**RE: Amendment No. 2017-01 – 2017 Annual Amendment
Removal Action Work Plan
Leviathan Mine Site, Alpine County, California
CERCLA Docket No. 2008-29**

Revised RAWP Amendment No. 2017-01

**ATTACHMENT A:
REVISED RAWP FIGURE 9 – GENERAL
SCHEDULE FOR TREATMENT ACTIVITIES**

Figure 9 - General Schedule for Treatment Activities

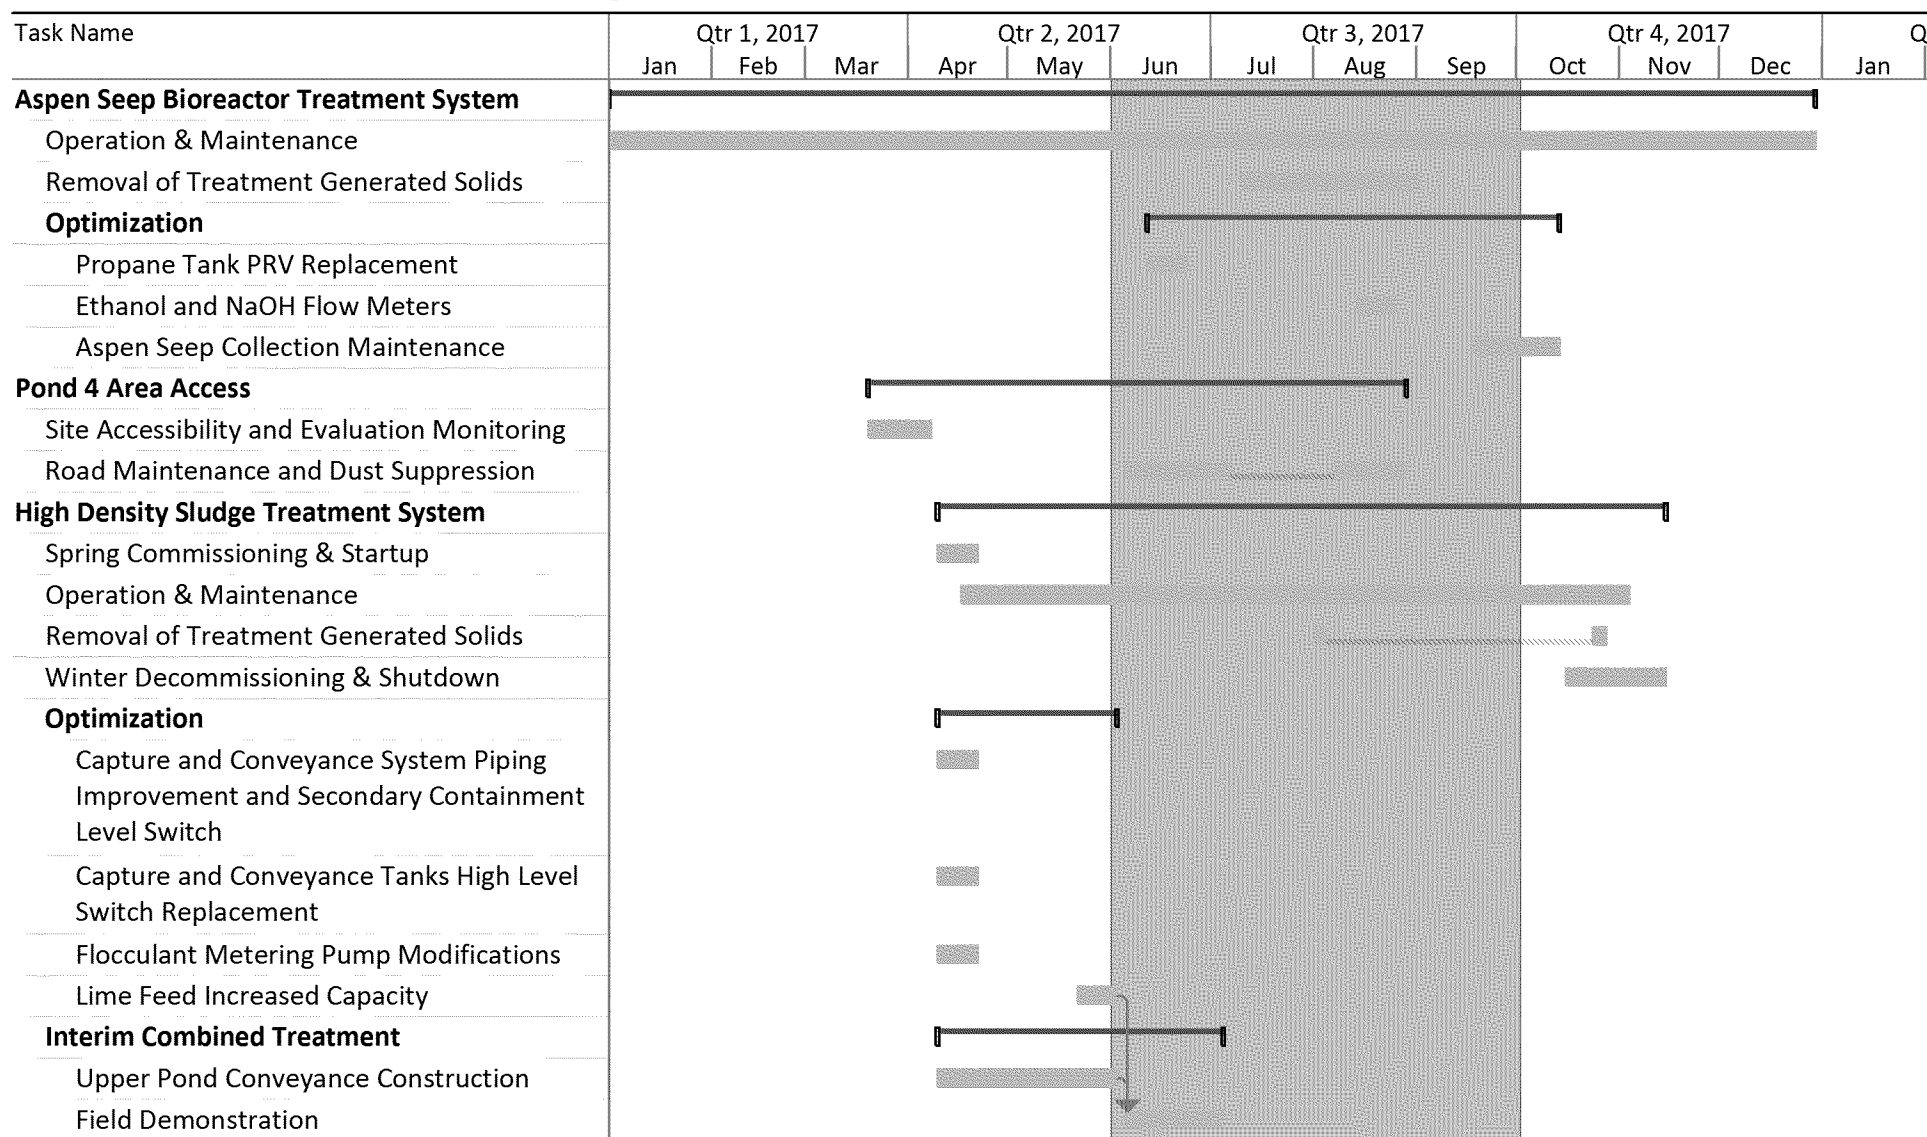
- *Figure 9* has been modified for each yearly amendment to reflect the proposed schedule for water treatment activities for 2017. A revised Figure 9 is included as Attachment A to this Amendment.

The following 2017 schedule projections for treatment-related activities are approximate and subject to change in the event of delays related to construction, administrative approvals, design changes, access restrictions, weather-related equipment problems, other circumstances inherent to working at a high altitude mine site with limited access, or other force majeure. A conceptual schedule showing the sequence and anticipated time frames for planned activities is attached to this letter as Attachment A – Revised RAWP Figure 9 – General Schedule for Treatment Activities.
